# INTERNATIONAL PLUMBING CODE

## P2-09/10, Part I

### Public Hearing Results

**Back of Water Heater**

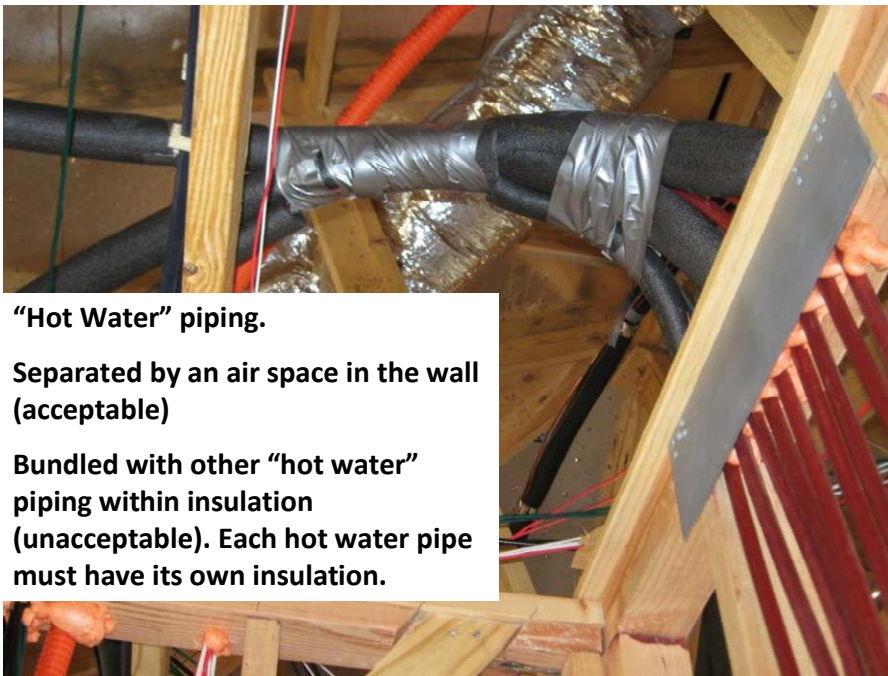
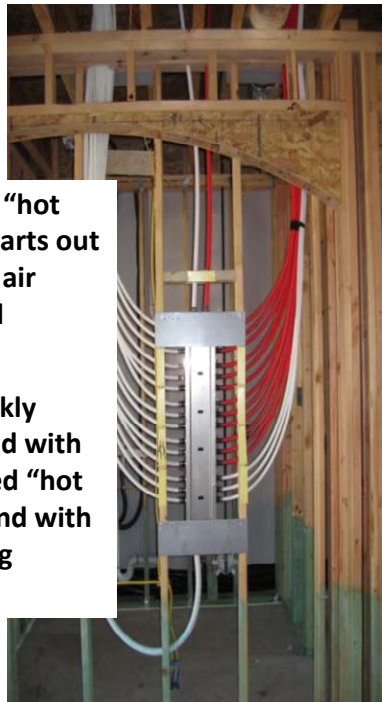
**Cold and uninsulated hot piping are bundled (unacceptable)**

**The uninsulated "hot water" piping starts out separated by an air space (acceptable), then gets bundled with other uninsulated "hot water" piping as it moves into the truss space (unacceptable).**

The uninsulated “hot Water” piping starts out separated by an air space in the wall (acceptable).

**308.9 Parallel water distribution systems.** Piping bundles for manifold systems shall be supported in accordance with Table 308.5. Support at changes in direction shall be in accordance with the manufacturer's installation instructions. ~~Cold water and uninsulated hot water piping shall not be grouped in the same bundle.~~ Where hot water piping is bundled with cold or hot water piping, each hot water pipe shall be insulated.
